Appendix M1
Design Quality Audit

Ringsend to City Centre Core Bus
Corridor

Quality Audit

Document Ref:	P23033-PMCE-ZZ-00-RP-QA-GEN-3_00_02
----------------------	--

A.2.2 Pedestrian Facilities between Pembroke Cottages and the Dodder Bridge/Tom Clark Bridge

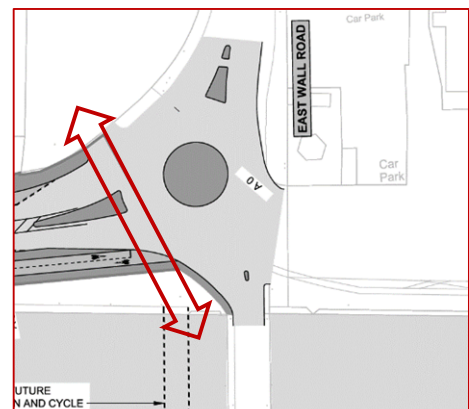
No pedestrian facilities have been indicated between the Zebra crossings at Pembroke Cottages, the new Dodder Sustainable Transport Bridge, and the Tom Clarke Bridge. It is therefore unclear how pedestrians in the Ringsend and Irishtown residential catchment areas will access the footways on the new Dodder Sustainable Transport Bridge or the existing Tom Clarke Bridge.

A pedestrian footpath, which ties in with a controlled crossing of York Road, should be provided between Pembroke Cottages and the new Dodder Sustainable Transport Bridge/Tom Clarke Bridge.

A.2.4 Footpath Effective Width

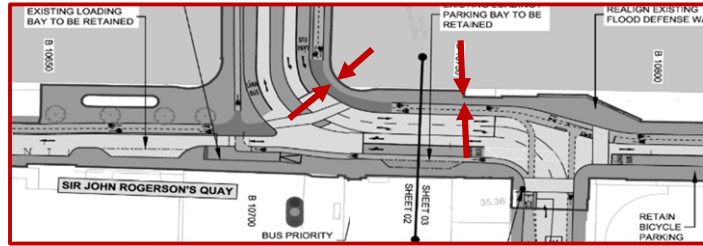
It is unclear if the proposed footway width at the junction between Samuel Beckett Bridge and Sir John Rogerson Quay can safely accommodate the likely volume of pedestrians at this location, in particular during peak times.

Ensure the footway is wide enough to accommodate the expected volumes of pedestrians.

A.2.5 Tactile Paving Provision

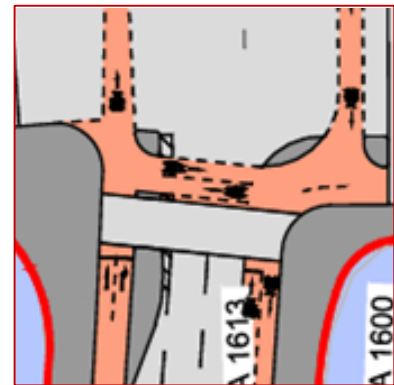
While tactile paving has not been indicated at this early stage in the design process, it will be required at all controlled & uncontrolled pedestrian crossings, and also at the interface between segregated pedestrian/cyclist facilities and shared surfaces, for example the shared surface which extends out to the “floating island” bus stop arrangements.

A lack of tactile paving within the scheme would lead to difficulties for the visually impaired in locating pedestrian crossings and being advised of transitions between shared, and segregated, facilities.

Appropriate tactile paving should be provided at all controlled & uncontrolled pedestrian crossings, and also at the interface between segregated pedestrian/cyclist facilities and shared surfaces.

In addition, measures will be required at the proposed “floating island” bus stop arrangements to ensure that visually impaired public transport users are guided safely to/from the bus stop and the adjacent footpath.

A.2.6 Trees Overhanging the Footpath

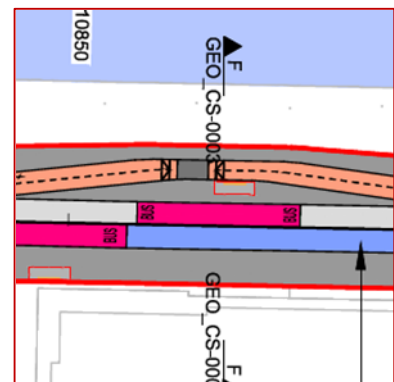
It is unclear from the drawings provided which trees are to be retained, and which are to be removed. A number of trees have been indicated positioned adjacent to the proposed footpath which may obstruct pedestrian movement.

Ensure retained/new trees, or other items of roadside furniture, do not present obstacles/hazards to pedestrians.

A.2.7 Lack of Guidance Paving at ‘Floating Island’ Bus Stops

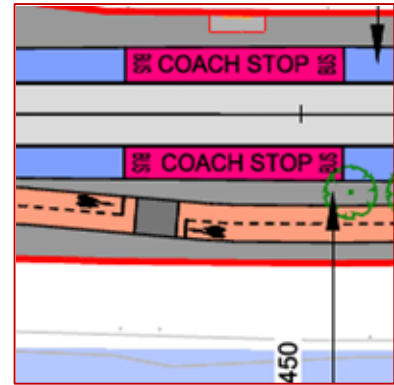
The general arrangement at ‘floating island’ bus stops includes extending a shared surface from the footpath to the edge of the traffic lane (e.g. a ‘Pedestrian Priority’ area catering for pedestrians, passengers and cyclists) with the cycle track joining the shared area through the bus stop location. At this early stage in the design process no tactile paving (either warning or guidance) has yet been indicated. An absence of Guidance Tactile Paving could result in increased difficulties for the visually impaired who may be unaware of how to access or leave the floating island when boarding/alighting a bus.

Guidance Tactile Paving should be provided to guide visually impaired pedestrians to/from the footpath & the bus stop.

A.2.9 Visually-impaired Pedestrians would be Guided to the Carriageway at York Road

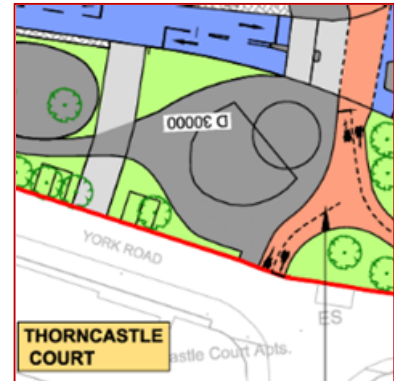
Pedestrians wishing to continue from the proposed Dodder bridge to York Road will be required to share the carriageway with motorised vehicles and, therefore, the section would be inaccessible to visually impaired pedestrians.

The proposed route should be made accessible to visually impaired pedestrians so that pedestrians are not required to share a carriageway with motorised vehicles.

Where this is not possible, a 'safe zone' for the visually impaired, free of vehicular traffic, should be provided with clear access between the footpath and this area provided.

A.2.10 Lack of Crossing Facilities at the Cambridge Road Roundabout

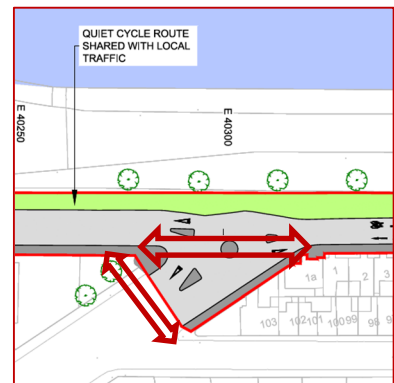
There may be a likely pedestrian desire line to/from the narrow footpath on each side of the York Road/Cambridge Road mini-roundabout. There are no existing, or proposed, pedestrian crossing facilities in the vicinity of the existing roundabout across Cambridge Road to cater for this pedestrian desire line and allow pedestrians to travel between the footpaths on each side of the carriageway.

Identify likely pedestrian desire lines and demand for vulnerable road users at the York Road/Cambridge Roundabout and provide pedestrian facilities where necessary.

B.2.3 Pedestrian Facilities between Pembroke Cottages and the Dodder Bridge/Tom Clark Bridge

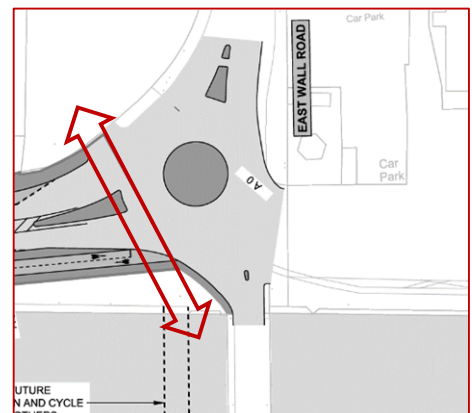
No pedestrian facilities have been indicated between the Zebra crossings at Pembroke Cottages, the new Dodder Sustainable Transport Bridge, and the Tom Clarke Bridge. It is therefore unclear how pedestrians in the Ringsend and Irishtown residential catchment areas will access the footways on the new Dodder Sustainable Transport Bridge or the existing Tom Clarke Bridge.

A pedestrian footpath, which ties in with a controlled crossing of York Road, should be provided between Pembroke Cottages and the new Dodder Sustainable Transport Bridge/ Tom Clarke Bridge.

B.2.5 Footpath Effective Width

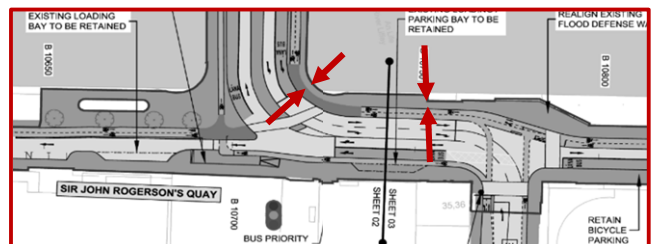
It is unclear if the proposed footway width at the junction between Samuel Beckett Bridge and Sir John Rogerson Quay can safely accommodate the likely volume of pedestrians at this location, in particular during peak times.

Ensure the footway is wide enough to accommodate the expected volumes of pedestrians.

B.2.6 Trees Overhanging the Footpath

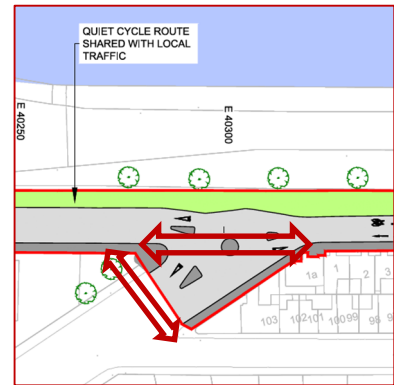
It is unclear from the drawings provided which trees are to be retained, and which are to be removed. A number of trees have been indicated positioned adjacent to the proposed footpath which may obstruct pedestrian movement.

Ensure retained/new trees or other items of roadside furniture do not present obstacles/hazards to pedestrians.

D.2.1 Lack of Separation between the Cycle Tracks and General Traffic

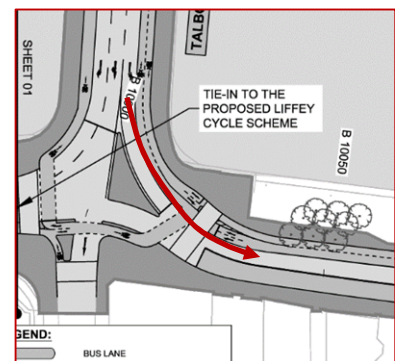
There is a lack of separation (vertical or kerb/bollard) indicated between the proposed two-way cycleway on the eastern side of the Talbot Memorial Bridge. Insufficient separation between the proposed cycle tracks and general traffic on Talbot Memorial Bridge could increase the risk of cyclists mixing with the general traffic, particularly turning left onto City Quay.

The existing northbound cycle lane on the western side of Talbot Memorial Bridge is located adjacent to the footpath and separated from the trafficked carriageway by a kerb. It is unclear from the drawing provided if this arrangement is to be retained.

The cycle tracks on Talbot Memorial Bridge should be physically separated from general traffic, and if possible from the footway also.

D.2.3 Trees Overhanging the Cycle Track

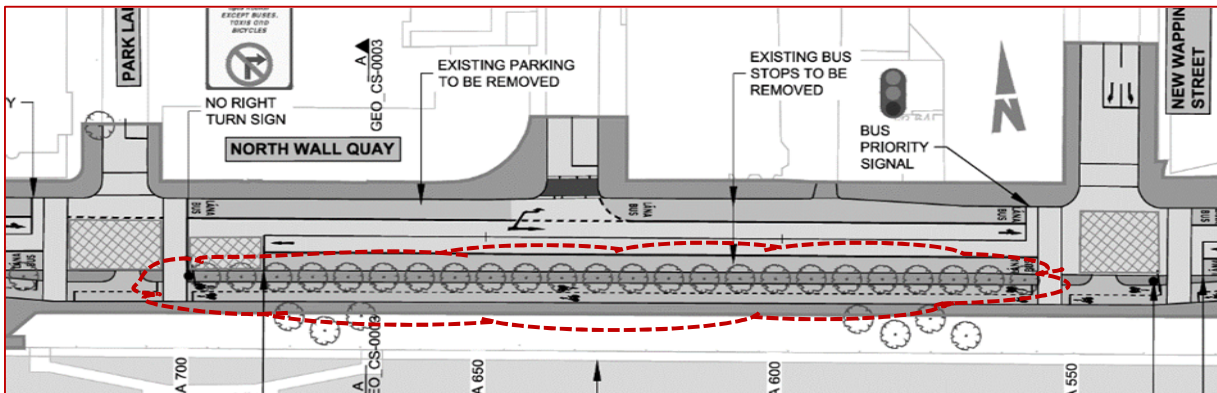
Tree planting is indicated on North Wall Quay, between CH A550 and CH A700. The tree canopies may, as they mature, overhang the cycle track. Low hanging tree canopies may present an obstacle to cyclists on the two-way cycle track.

Care will be required during the subsequent Design Development phases to ensure that the tree species chosen have canopies, when mature, that will not present a hazard to vehicles travelling in the adjacent bus lane, or to cyclists on the two-way cycle track.

D.2.4 Removal of Vehicle Restrictions on Pigeon House Road

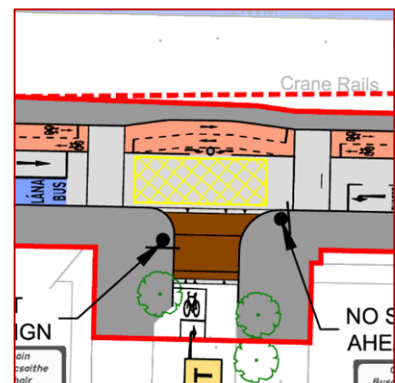
Dublin City Council is currently (March 2023) trialling a vehicular access restriction on Pigeon House Road. The restriction prevents motorists on Pigeon House Road from accessing the Sean Moore Road Roundabout, and vice versa. It is unclear if the Ringsend to City Centre Core Bus Corridor Scheme proposes to remove the restriction on through-traffic on the Pigeon House Road.

Removing any existing restrictions could result in a significant diversion of traffic through the relatively narrow local streets to the west of this location, along which it is intended to route cyclists to/from the new facilities on Sir John Rogerson’s Quay.

The Design team should consult with Dublin City Council to understand the trial’s conclusions before determining whether the restriction should be retained or removed.

D.2.6 Cycle Lane Blocked by Passengers

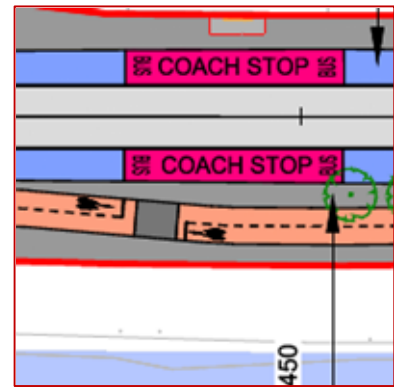
The width of the floating islands at bus stops on North Wall Quay within the scheme is not indicated on the drawings provided, however, they appear to be narrow. Should pedestrians waiting for a bus choose to wait within the islands, there is a risk that they could encroach into the cycle track where they would impede cyclists.

Ensure the floating islands at bus stops throughout the route can accommodate pedestrians such that do not encroach into the cycle track.

D.2.7 Potentially Unsafe Cyclist Entry to the Roundabout

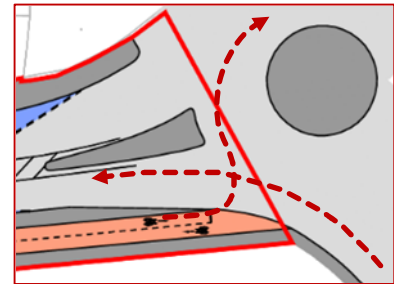
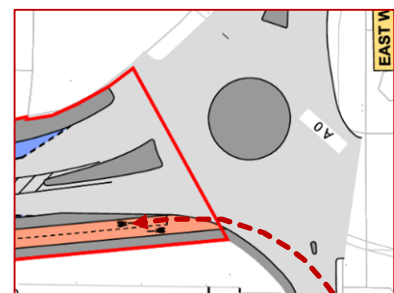
A two-way cycle track is indicated on the southern side of North Wall Quay adjacent to the westbound traffic lane. Eastbound cyclists in the two-way cycle track approaching the East Wall Road/North Wall Quay/Tom Clarke Bridge roundabout would be required to enter the circulating carriageway at a location where motorised vehicles turning left from Tom Clarke Bridge would be exiting the roundabout increasing the risk of conflicts between cyclists entering the roundabout and vehicles exiting it.

The potential future pedestrian and cycle bridge at this location is acknowledged and, if constructed, would go some way to resolving this issue as it would allow left-turning cyclists to use this bridge rather than the circulating carriageway. The issue, however, would still remain for cyclists travelling from the eastbound cycle track to East Wall Road.

The proposed layout should be amended to provide a safe route for cyclists turning left from the eastbound cycle track and East Wall Road.

D.2.9 Parking at York Road

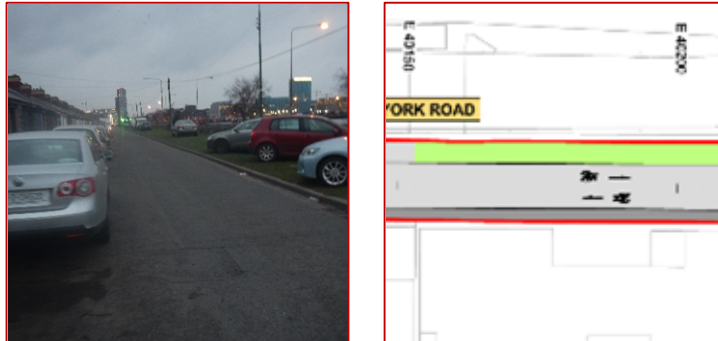
During the site visit, a number of vehicles were observed parked on the southern side of York Road, and within the grass verge on its northern side, leading to a reduced effective width within the carriageway that can be used by cyclists and vehicles.

A shared surface for cyclists and vehicles is indicated on York Road as part of the proposed scheme. Should this parking continue within the proposed shared surface, the reduced width may impede cyclist movements.

Measures should be provided to prevent parking within the shared surface on York Road.

D.2.10 Full Height Kerb

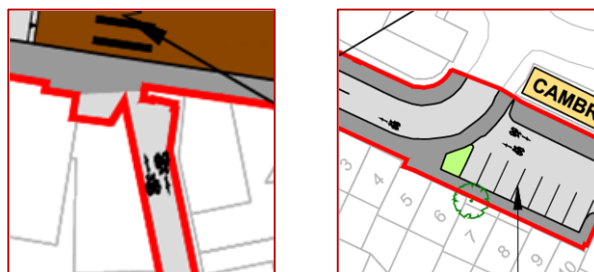
The absence of a dropped kerb at the locations where cyclists may enter/exit the cycle track when travelling to/from Canon Mooney Gardens and at Pembroke Cottages where it intersects Pigeon House Road may lead to cyclists having to mount/dismount a full height kerb.

Dropped kerbs, with an upstand that can be detected by a visually impaired pedestrian but safely traversed by cyclists, should be provided at the entrance to/exit from the cycle track.

D.2.12 Cycle Friendly Gullies

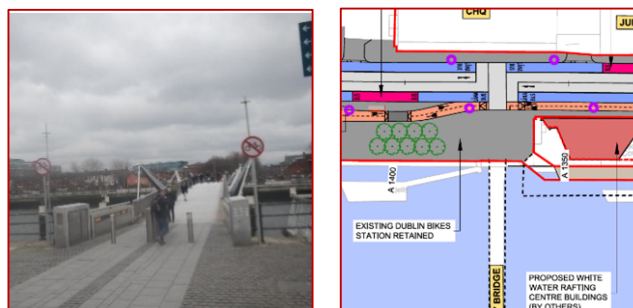
At this early stage in the design process, details regarding drainage and the location of gullies, if any, have not been provided to the Audit Team. It is therefore unclear if, and what type of, gullies are to be proposed within the Scheme. If gullies, not suitable for cyclists, are located within cycle tracks there is a risk that cyclists may swerve into the traffic lane to avoid these.

At detailed design stage, if gullies are required within cycle tracks ensure that cycle friendly gullies are provided, and that they are flush with the surrounding pavement.
